Feed Assembly, 3" Cutting Head (62659)

Manual Page Number	Revision

Locations of Sensor Leads on the Safety Monitor					
Switch Number	**1**	**2**	**3**	**4** (Grease Spindle Only)	**6** (Oil Mist Spindle Only)
Guard	Belt Guard	Upper Cutting Enclosure	Feed Hopper	Rear Guard	Oil Pressure and Level Switches
Switch Input	IN1	IN2	IN3	IN4	IN6

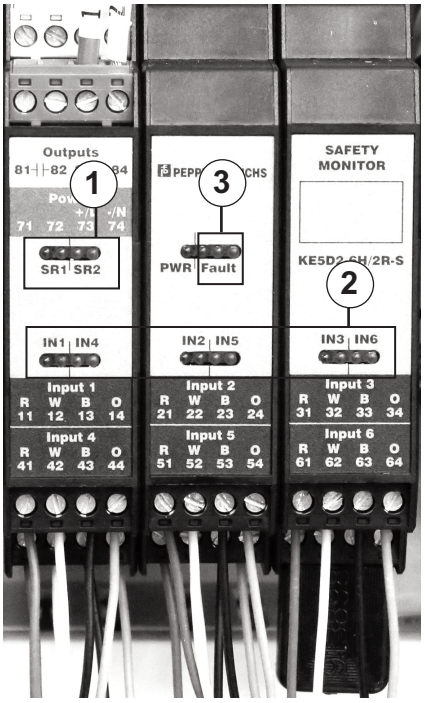
Safety, Safety Switch System Test: The electrical enclosure as currently supplied uses a safety monitor instead of an amplifier. The safety system test procedure is the same; refer to the entry on the previous page for information on the safety monitor. Perform the safety switch test **daily**.

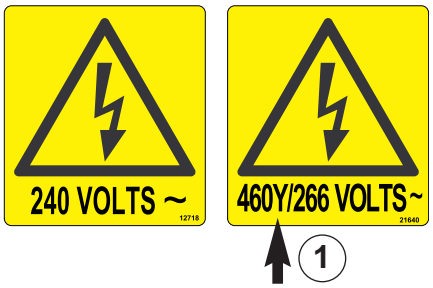
Installation – Electrical Power:
add to Step 1: A machine with a hazard alert label with a ***"Y" (1)*** in the voltage designation contains mini circuit breakers (MCBs) and requires a Wye power supply. To check for a Wye power supply, first calculate the voltage to ground by multiplying the supply voltage by .577. Next, measure the voltage at each phase to ground and compare to the calculated value.

For example, at 400 volts, a Wye supply will measure approximately 230 volts from one phase to ground (400 x .577). One phase may read 0 volts, which is acceptable. A Delta supply at 400 volts will measure 400 volts from one phase to ground. If the machine is supplied with mini circuit breakers or the label designates a Wye power supply, and the voltage from one phase to ground exceeds 277 volts, contact an Urschel service representative.
